SERVICE BULLETIN

M-922

1986 FLTC AND FLHT/C MODELS REAR BRAKE CALIPERS

Figure 1. Retainer Clip Installation

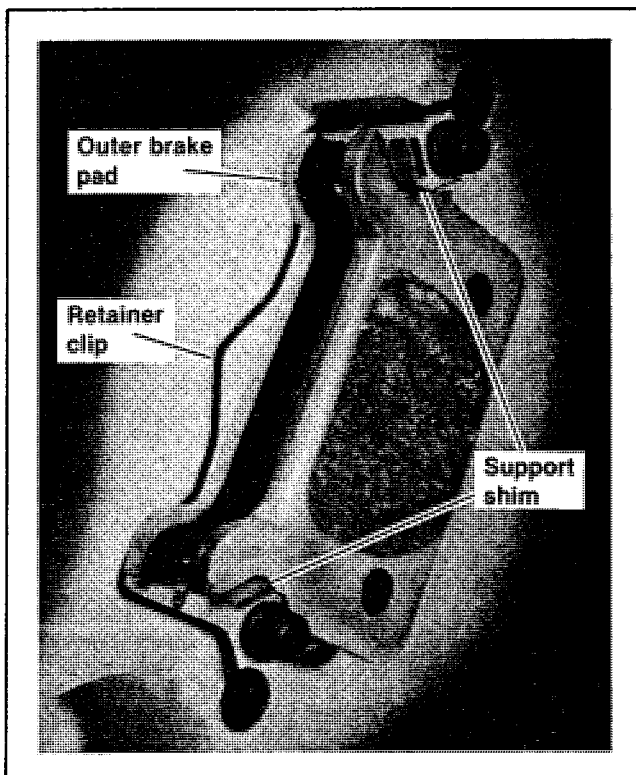
See Figure 1. A brake pad retainer clip has been added to the rear caliper bracket on 1986 FLTC and FLHT/C models. (Some early production motorcycles do not have the clip). The retainer clip keeps the outer (piston-side) brake pad in position during rear wheel removal or installation. If the outer pad is forced off the caliper bracket support shims, brake drag and rapid wear of the caliper bracket may result.

The Holder, Pad and Insulator Kit, Part No. 43957-86A, contains a retainer clip. Figure 1 shows how the retainer clip must be installed.

Figure 2. Rear Caliper

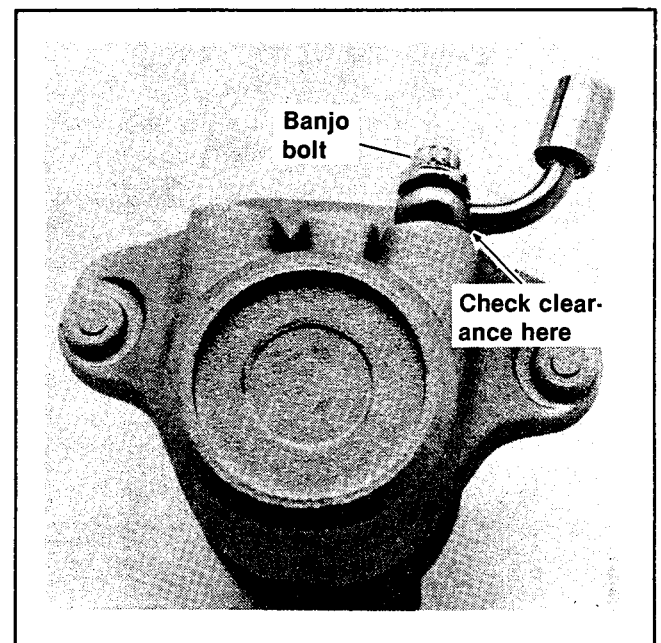
Some 1986 FLTC and FLHT models may have rear brake calipers with a high lip partially surrounding the spot face at the brake line connecting hole. This lip may contact the banjo fitting, if banjo fitting is turned partially inward.

1. Remove right saddlebag and side cover.
2. See Figure 2. Check that clearance is present between curved portion of banjo fitting and caliper.

3. If curved portion of banjo fitting is touching the lip surrounding the spot face, remove the banjo bolt.
4. Place new sealing washers on top and bottom of banjo fitting, install banjo bolt and finger tighten.
5. Turn the banjo fitting to a forward facing position (away from lip) and check if clearance is now present at location shown in Figure 2.
6. If clearance is present, tighten banjo bolt to 30-35 ft-lbs torque and bleed rear brake system.
7. If clearance cannot be obtained by turning banjo fitting, remove the banjo bolt and fitting.

Figure 3. Removing Spot Face Lip

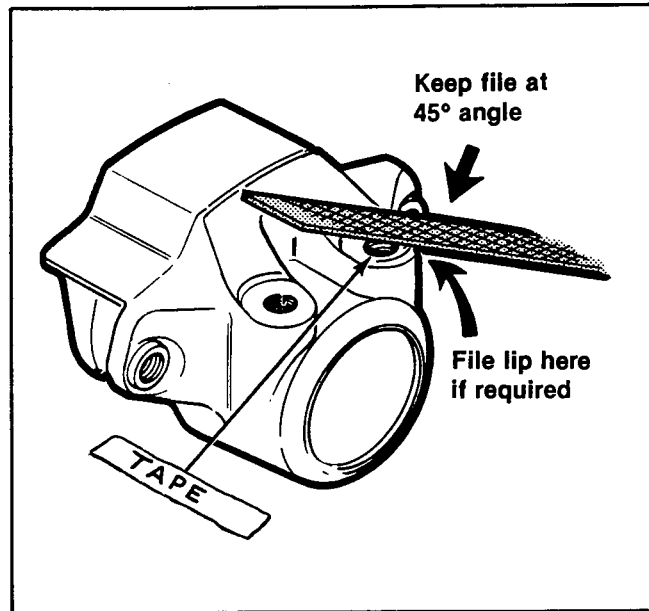
8. See Figure 3. With a file remove that portion of the lip that contacts the banjo fitting.

Do not mar spot face sealing surface with the file. A damaged sealing surface could cause brake fluid leakage and reduced braking efficiency.

9. After the lip interference has been removed, perform Steps 4 through 6.
